**Project:** Richmond Rd M7 Motorway to Townson Road

**Phase:** Substantial Detailed Design (Review 2 of 2)

**Package:** Culverts

**Date of Issue:** 29 May 2026

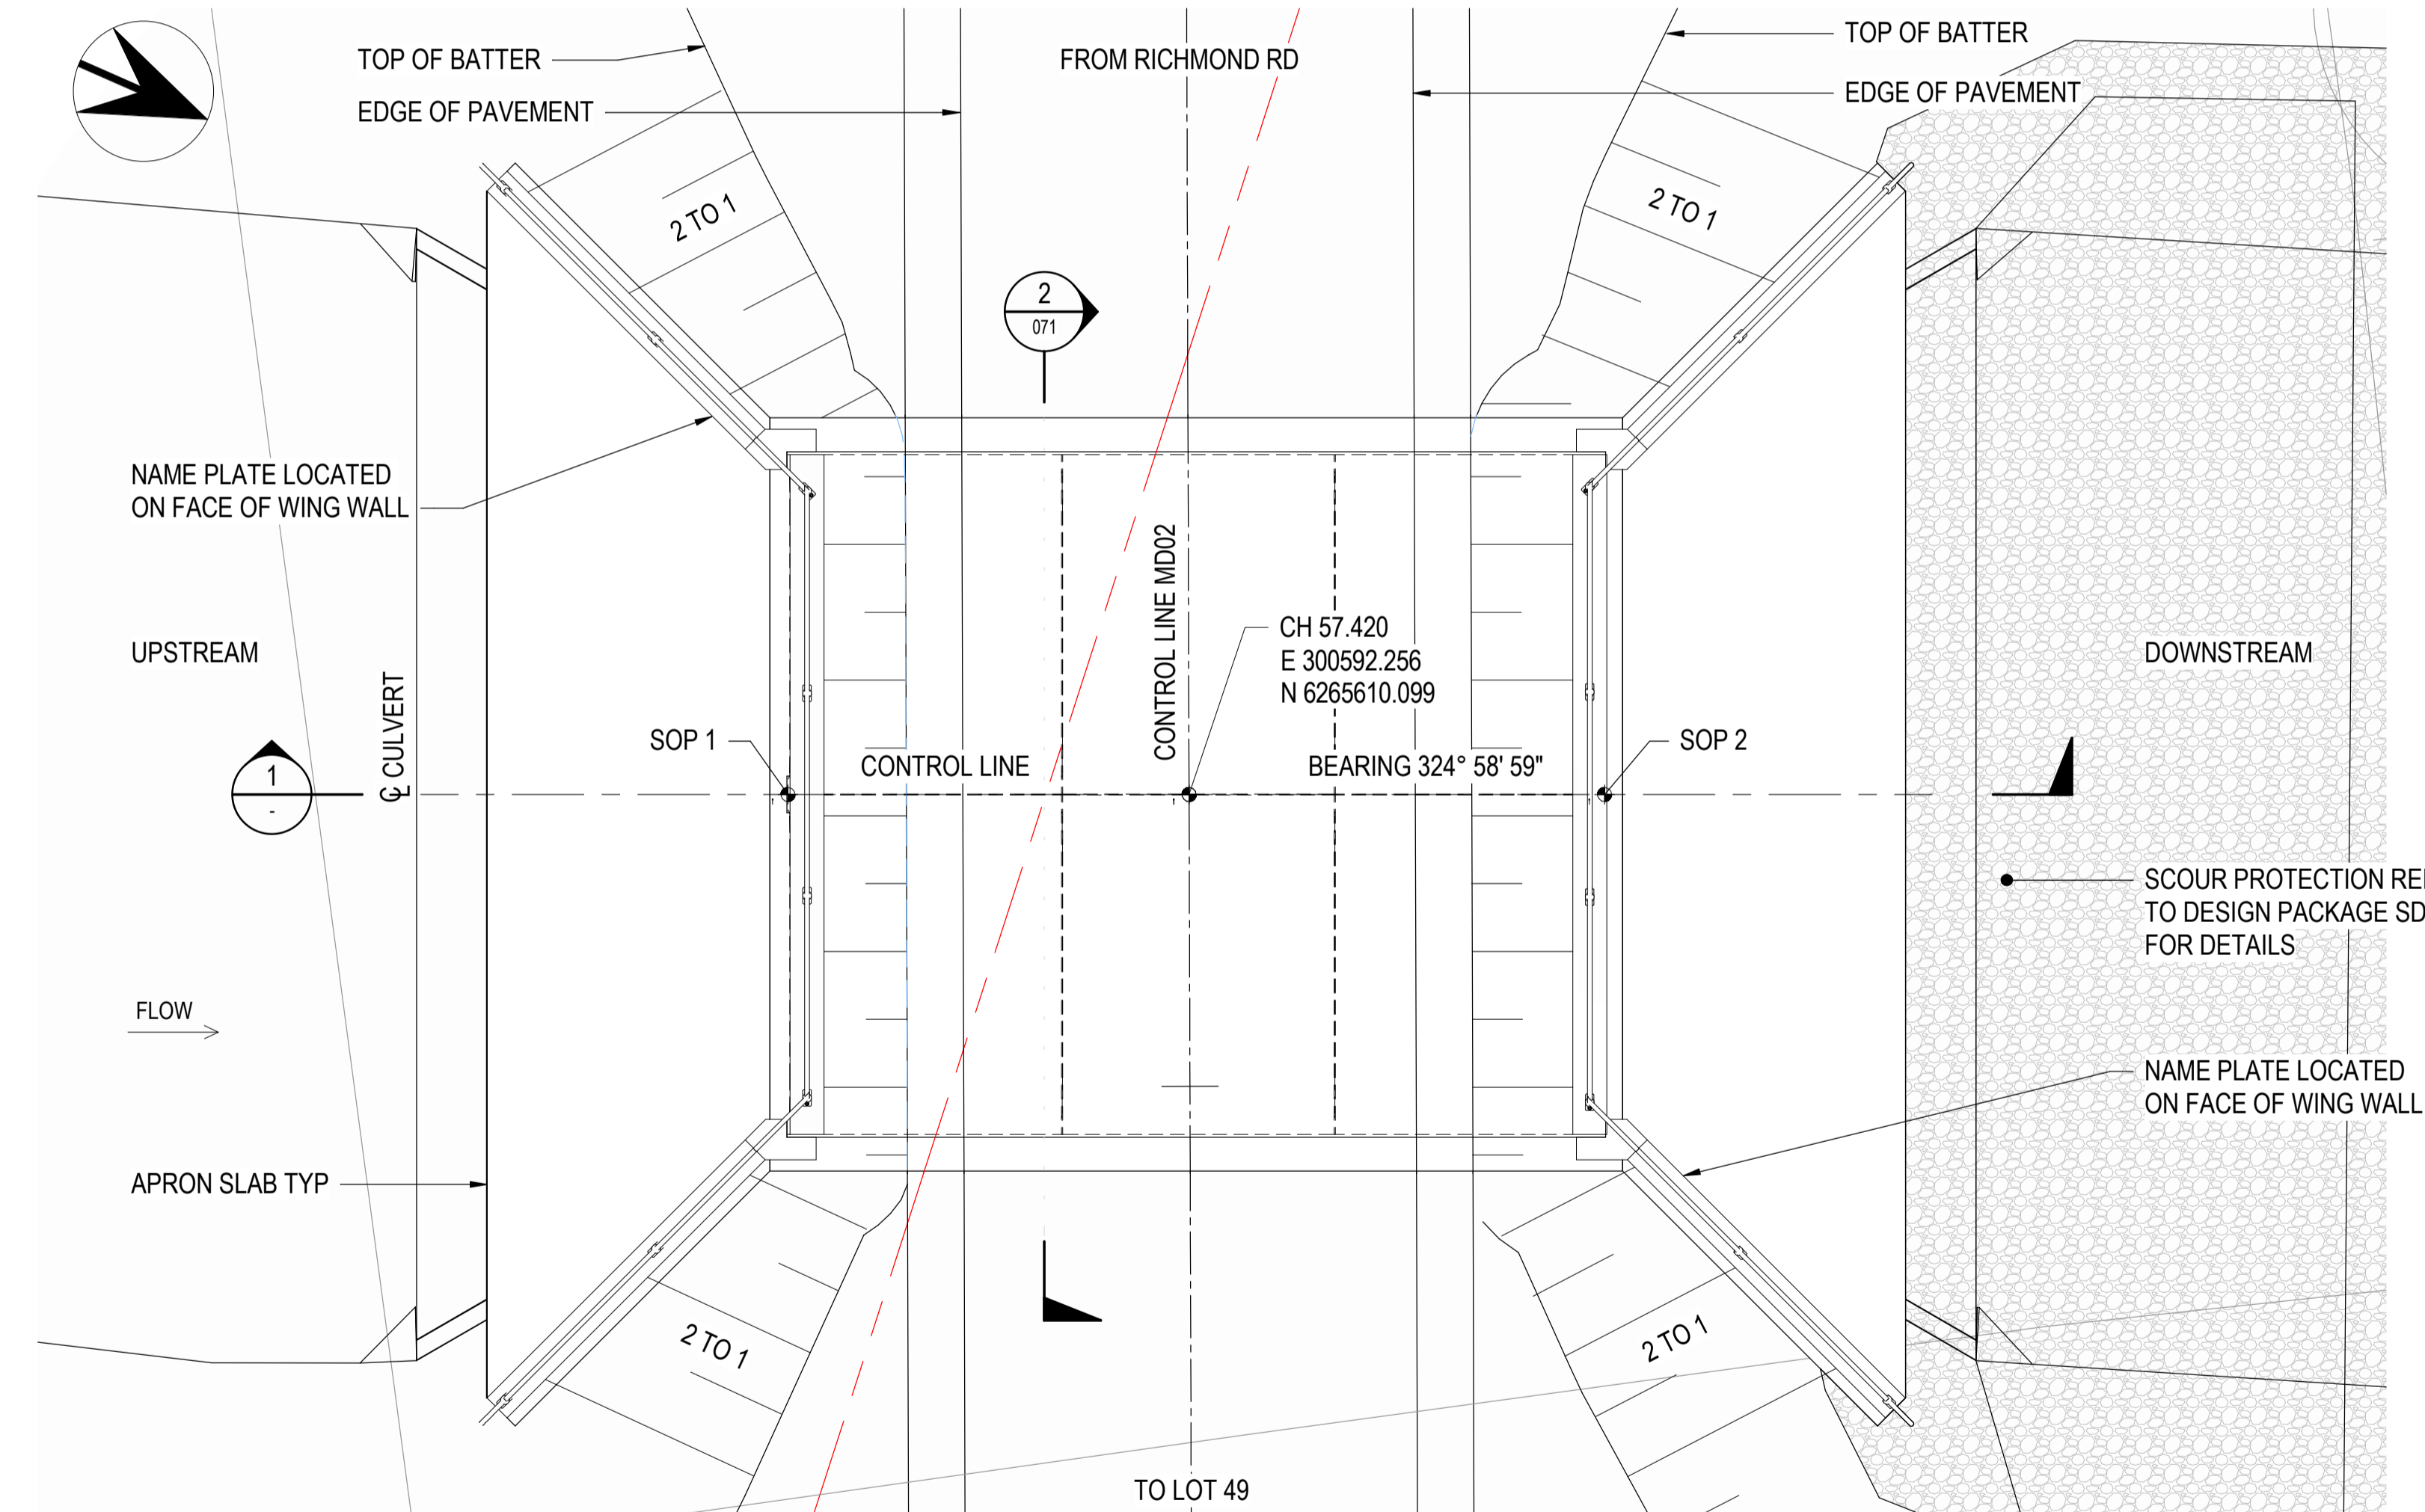
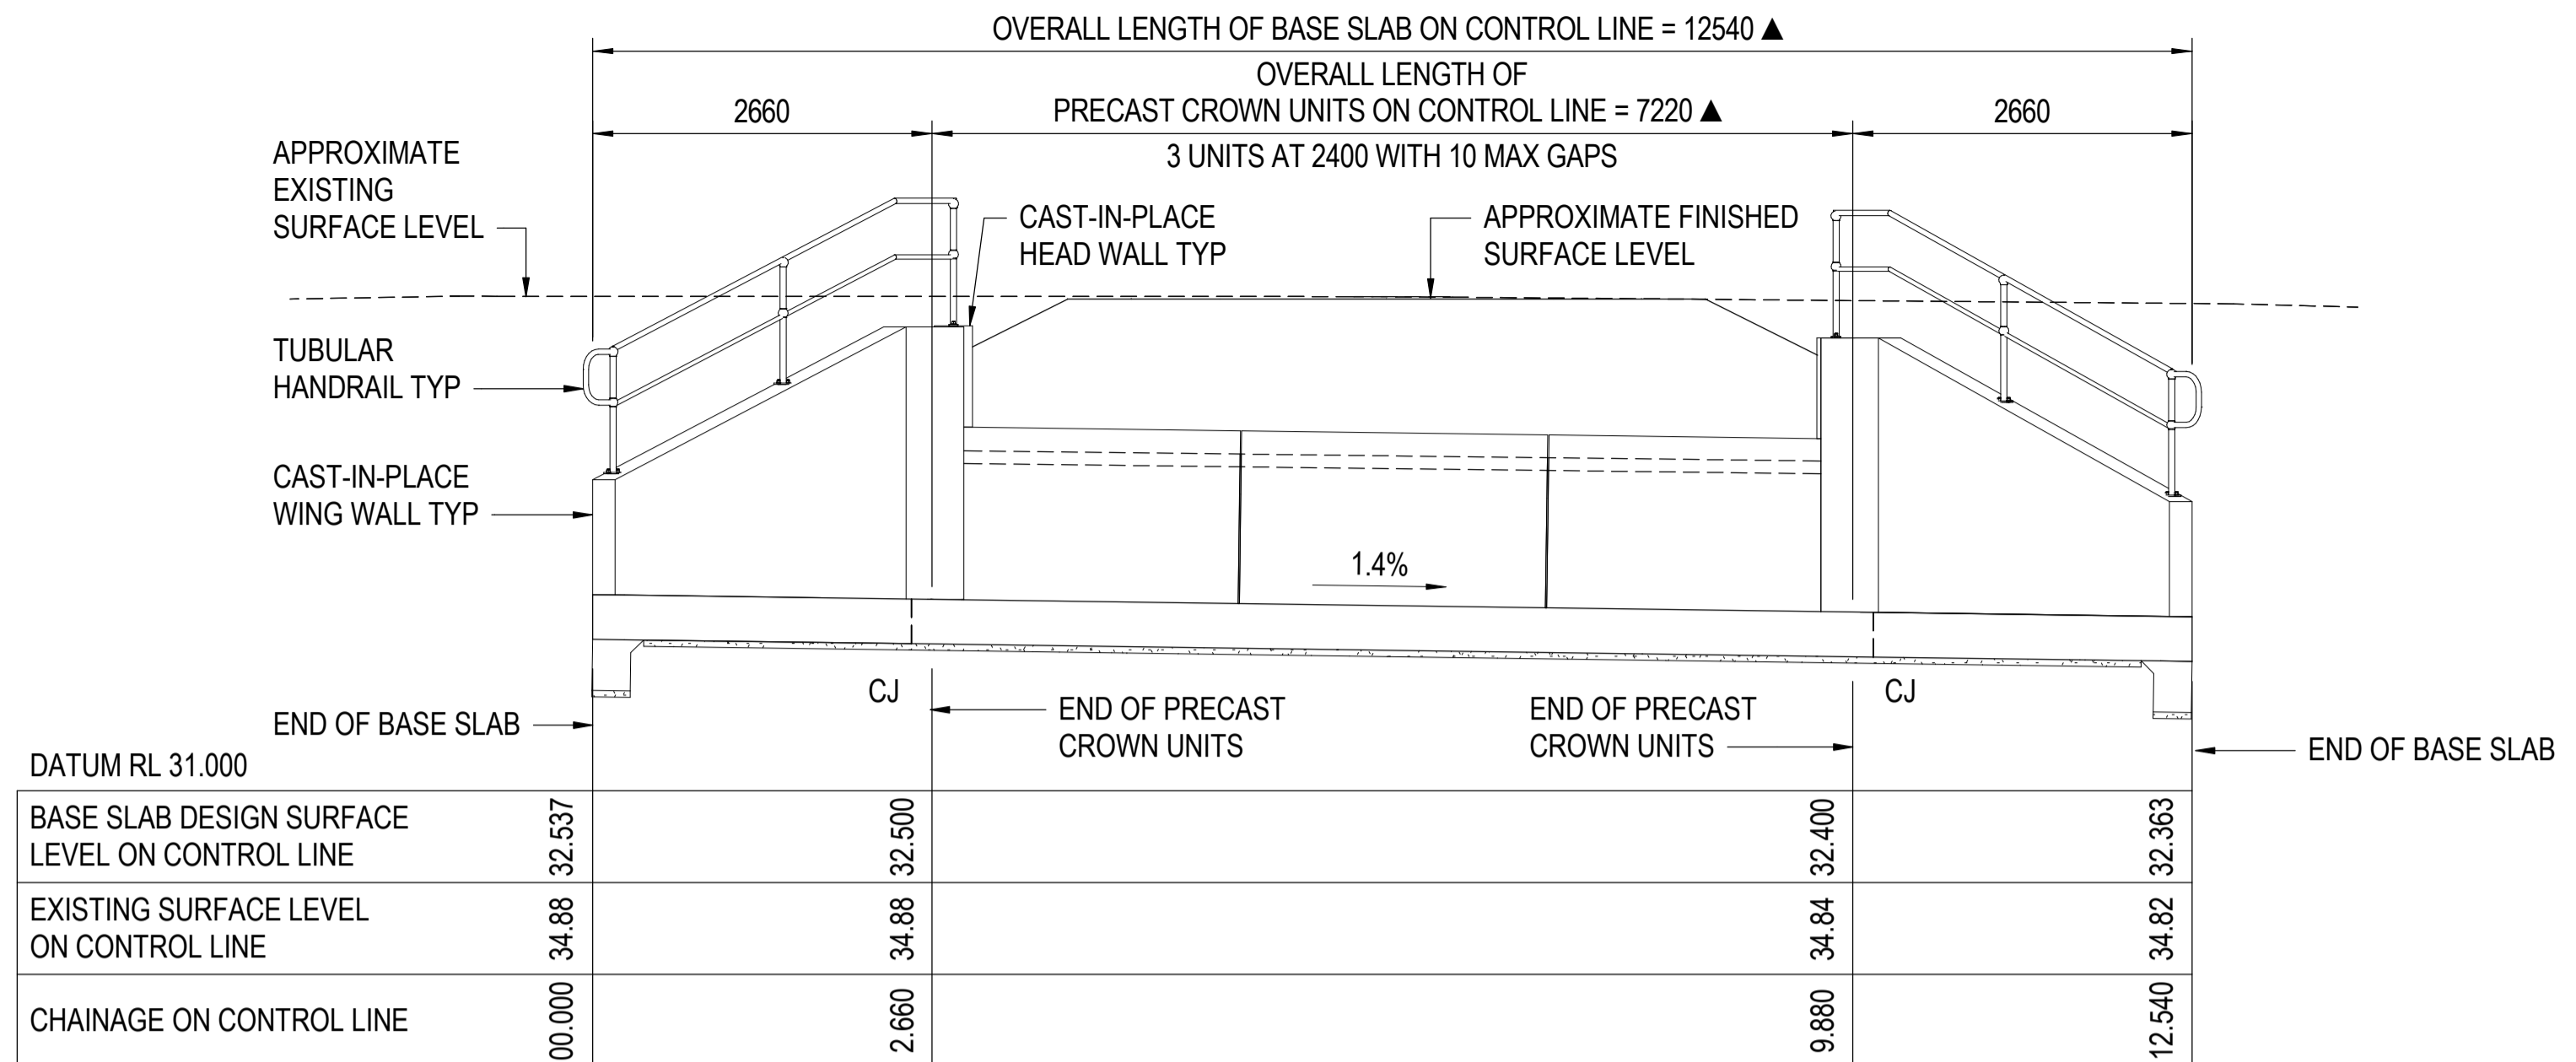
The overall footprint of this culvert structure has reduced in length by 1210mm. No other changes are proposed.
